**SUNDRY NOTICES AND REPORTS ON WELLS**  
**Do not use this form for proposals to drill or to re-enter an abandoned well. Use Form 3160-3 (APD) for such proposals.**

Mewbourne Oil Company requests approval to make the following changes to the approved APD (30-015-55811):

<b>OPERATOR'S NAME:</b> MEWBOURNE OIL COMPANY
<b>WELL NAME &amp; NO.:</b> CREEDENCE 21/16 FED COM 558H
<b>APD ID:</b> 10400087578
<b>LOCATION:</b> Section 28, T.24 S., R.28 E. NMP.
<b>COUNTY:</b> <span style="border: 1px solid black; padding: 2px;">Eddy County, New Mexico ▼</span>

Mewbourne Oil Company, Creedence 21/16 Fed Com 558H  
 Sec 28, T24S, R28E  
 SHL: 100' FNL 905' FEL (Sec 28)  
 BHL: 100' FNL 600' FEL (Sec 16)

**CREEDENCE 21/16 FED COM #558H**

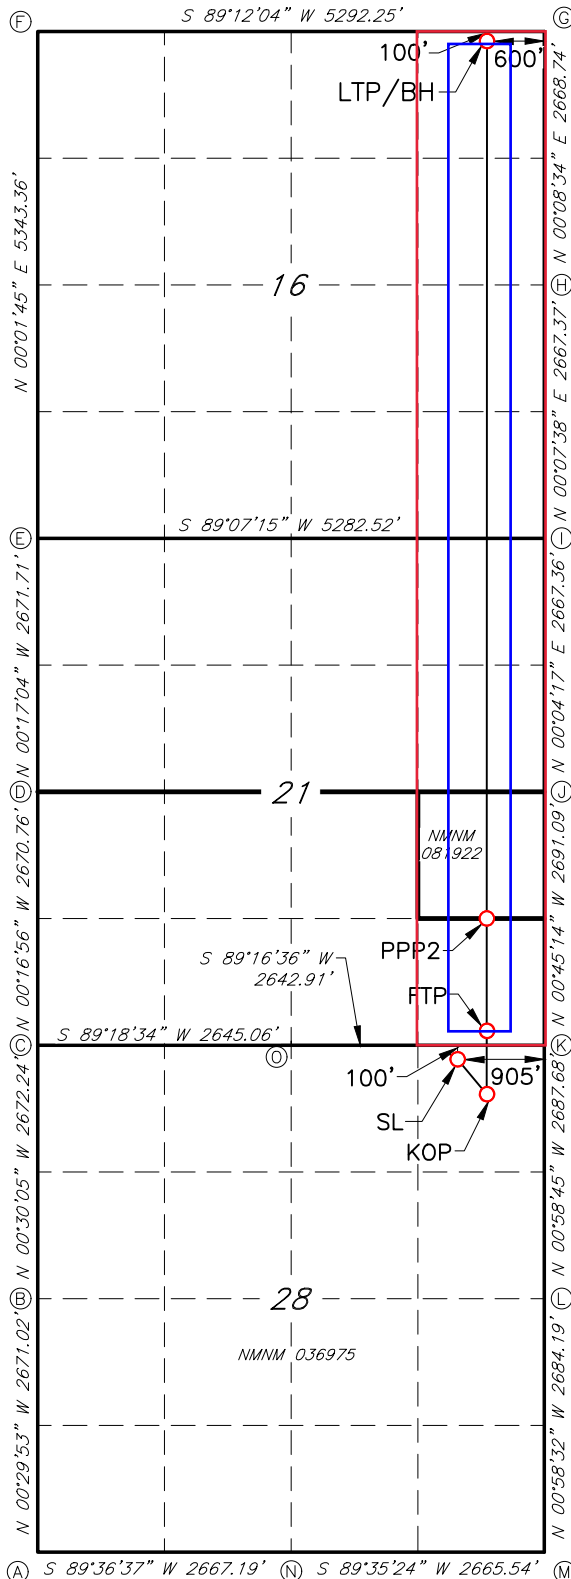
- 1) Change SHL from 300' FNL & 945' FEL, Sec 28, T24S, R28E to 100' FNL & 905' FEL, Sec 28, T24S, R28E.
- 2) Change BHL from 330' FNL & 2180' FEL, Sec 16, T24S, R28E to 100' FNL & 600' FEL, Sec 16, T24S, R28E.
- 3) Add proposed penetration of NMNM 81922, as detailed in the attachments.
- 4) Change pool from Purple Sage; Wolfcamp, Gas (98220) to Corral Canyon; Bone Spring, South, Oil (13354).
- 5) Change casing & cement design to suit new directional plan, as detailed in the attachments.

SURFACE LOCATION (SL)  
 100' FNL & 905' FEL SEC.28  
 N: 435026.5 - E: 617531.9  
 LAT: 32.1957252° N  
 LONG: 104.0870110° W

LAST TAKE POINT/BOTTOM HOLE (LTP/BH)  
 100' FNL & 600' FEL SEC.16  
 N: 445721.4 - E: 617815.4  
 LAT: 32.2251226° N  
 LONG: 104.0860151° W
